Re: Notice of Intent – Supplement #1  
Rocky Hill MBTA Community at Elm Street  
265, 277, 281, 287, and 287½ Elm Street, Amesbury, Massachusetts  
MassDEP File #002-1362

Re: Peer review response and revised plan submission  
Application: Site Plan Review  
Property: Rocky Hill MBTA Community: Elm Steet

Re: Proposed Rocky Hill MBTA Community Development  
Elm Street, Amesbury, Massachusetts  
**Site Plan and Civil Engineering Peer Review**

FIGURE 1.2

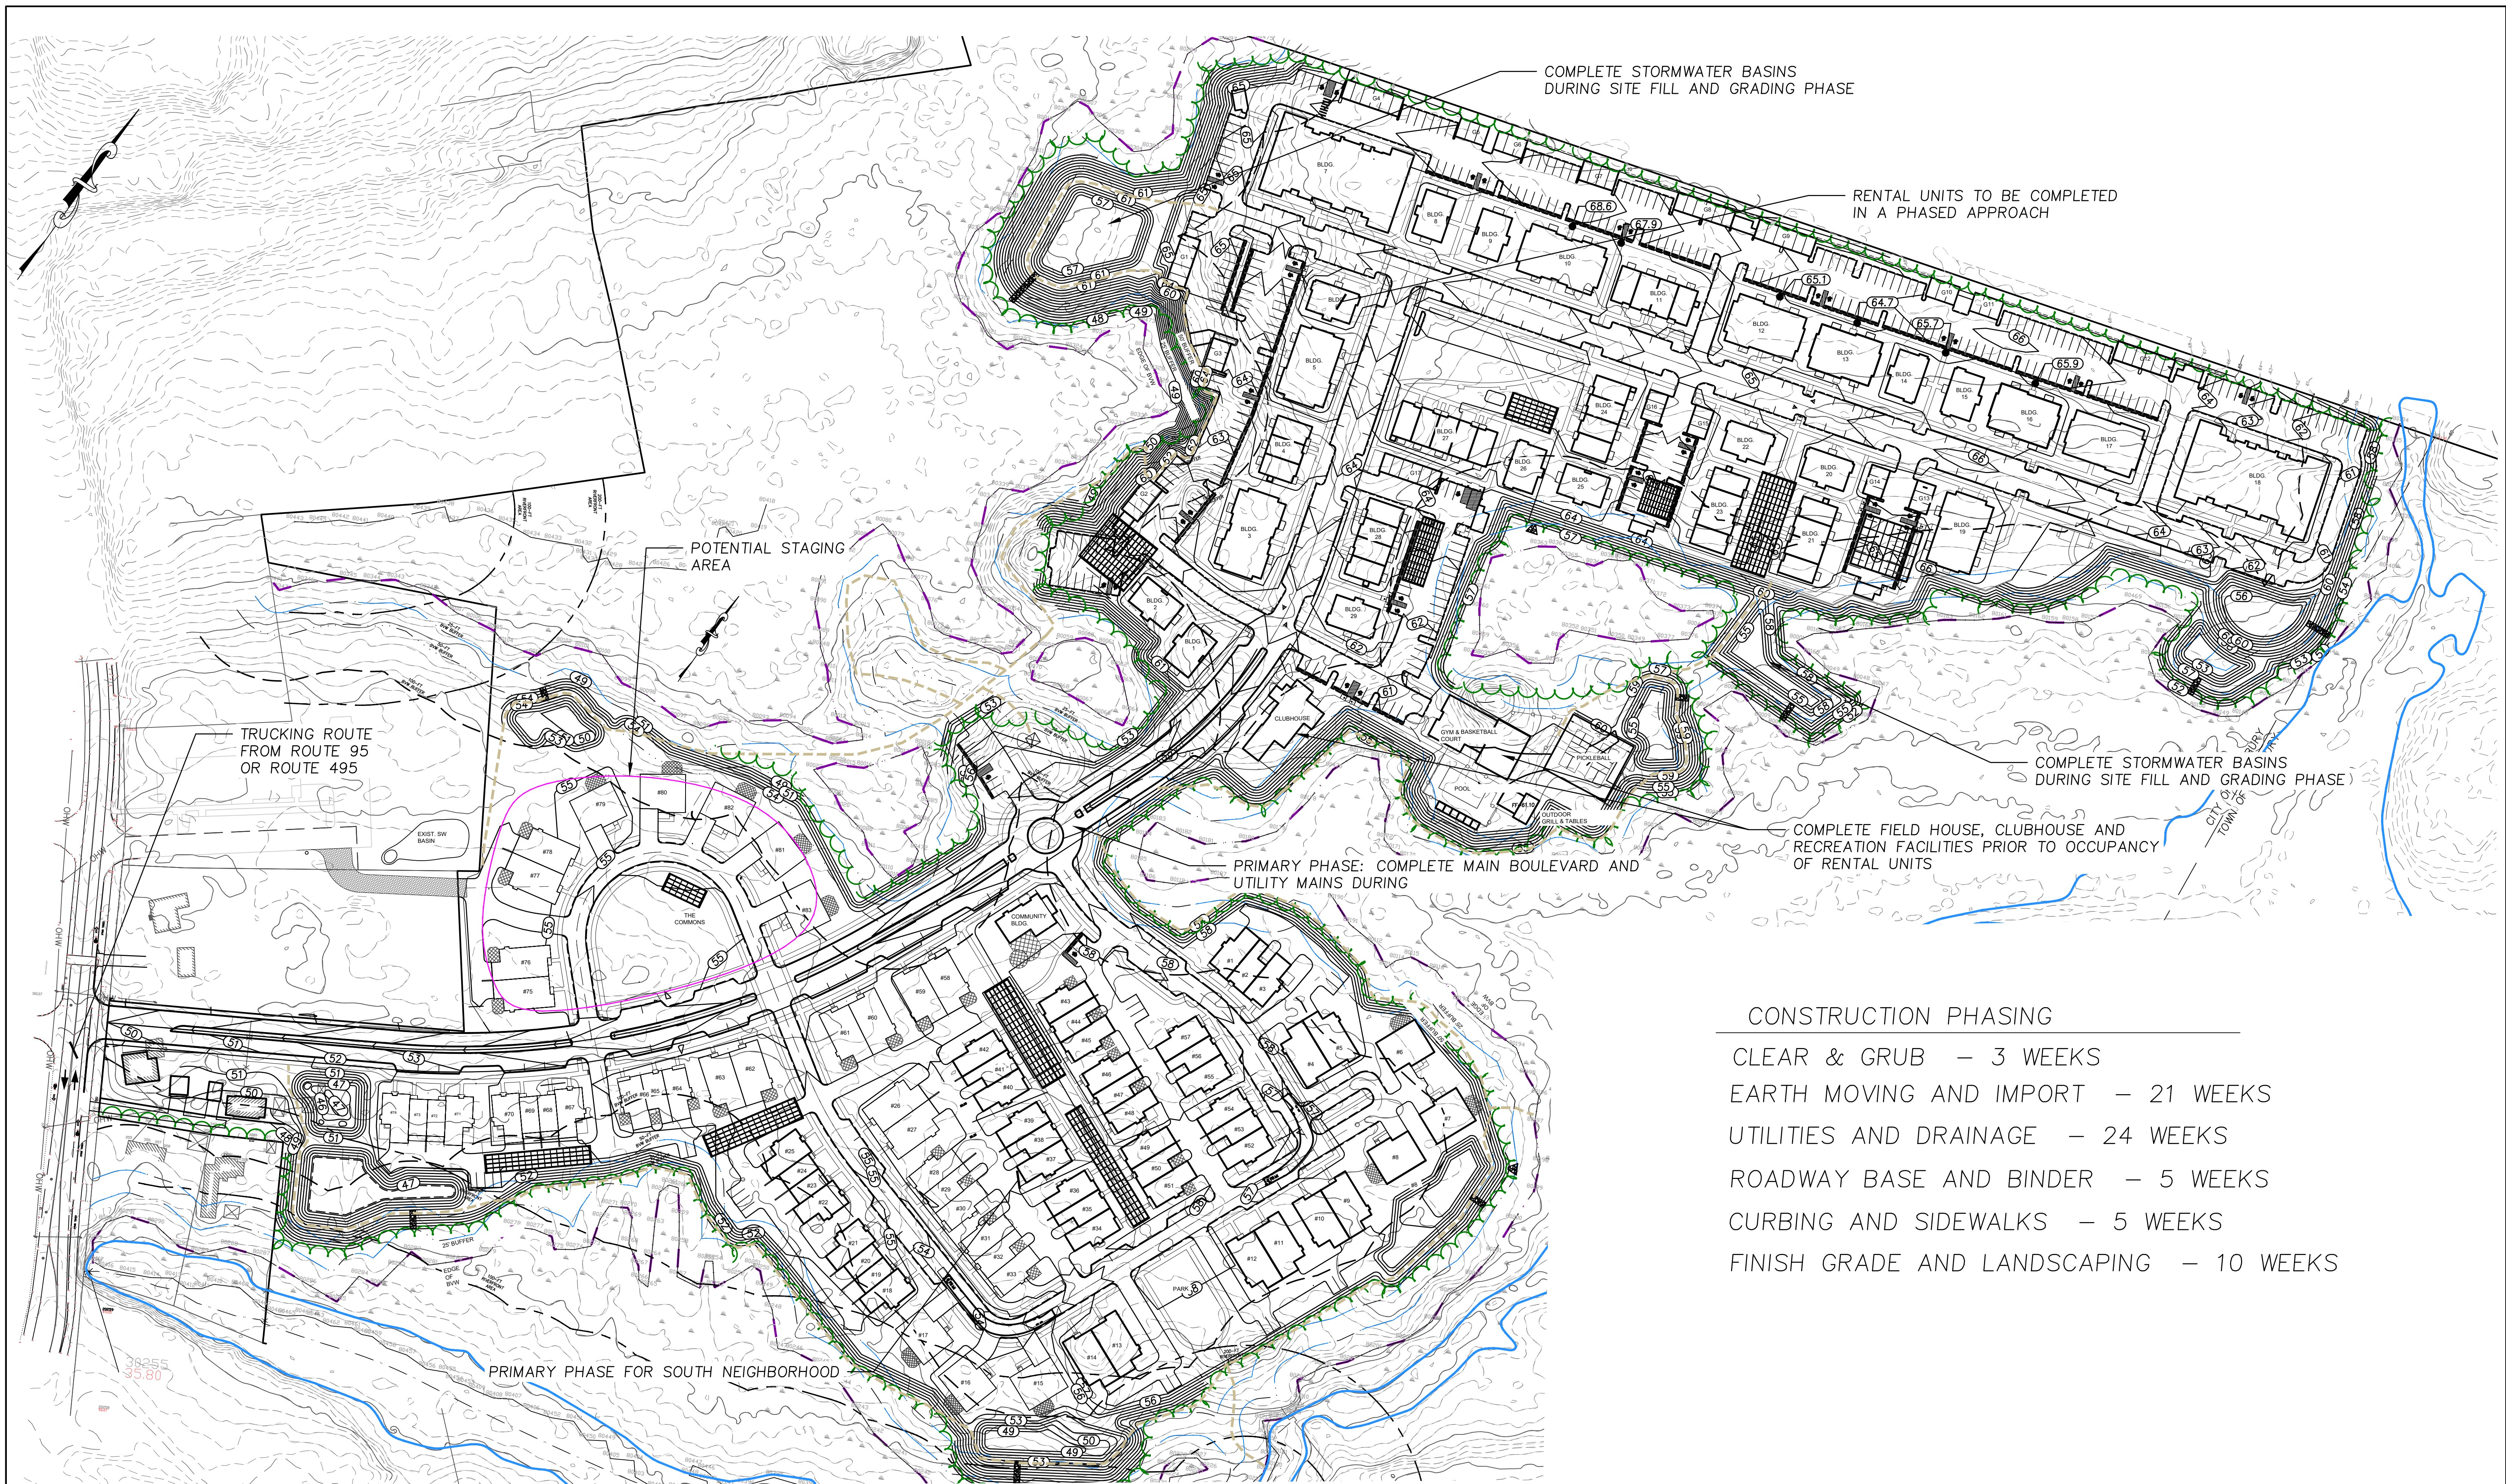
**VHB Comment:** The submitted grading plans depict substantial areas of cut and fill throughout the site; however, the materials do not include a quantitative earthwork summary (cut/fill calculations or balance analysis), nor do they clearly indicate whether material will be exported from or imported to the site. While the project is not before the Board as a Definitive Subdivision, Section XI.Q.10.5.a.5 incorporates applicable Subdivision standards for purposes of Site Plan Review, and earthwork magnitude is relevant to evaluating grading impacts, site stability, and community effects.
